LR-N15-0084
LAR S14-04

Salem Nuclear Generating Station Units 1 and 2
Renewed Facility Operating License Nos. DPR-70 and DPR-75
NRC Docket Nos. 50-272 and 50-311

Subject: License Amendment Request Modifying Chilled Water System
Requirements

Figure 4-1 Simplified AB CH System Diagram
(Typical for both units except where indicated; Unit 2 component designations used)

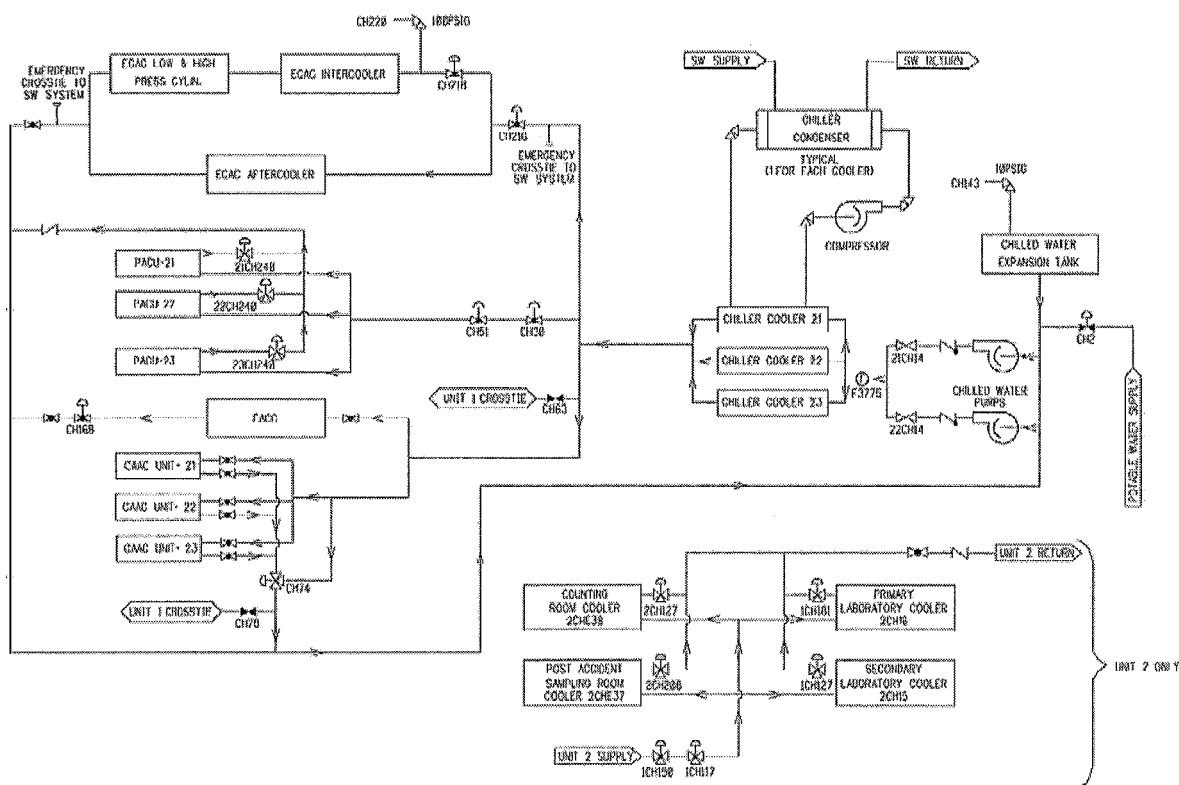
The AB CH system for each Unit contains the following major components (a simplified diagram of the Unit 2 CH system is shown in Figure 4-1).

As shown in the diagram, the cross-tie valves (1CH63 and 1CH78) are manual valves and will remain manual valves with the proposed TS changes. Prior to use of the cross-tie, the valves and cross-tie line-up will be tested to confirm required performance. The failure mode and effects analysis (FMEA) has determined the cross-tie configuration does not introduce any new failure modes.
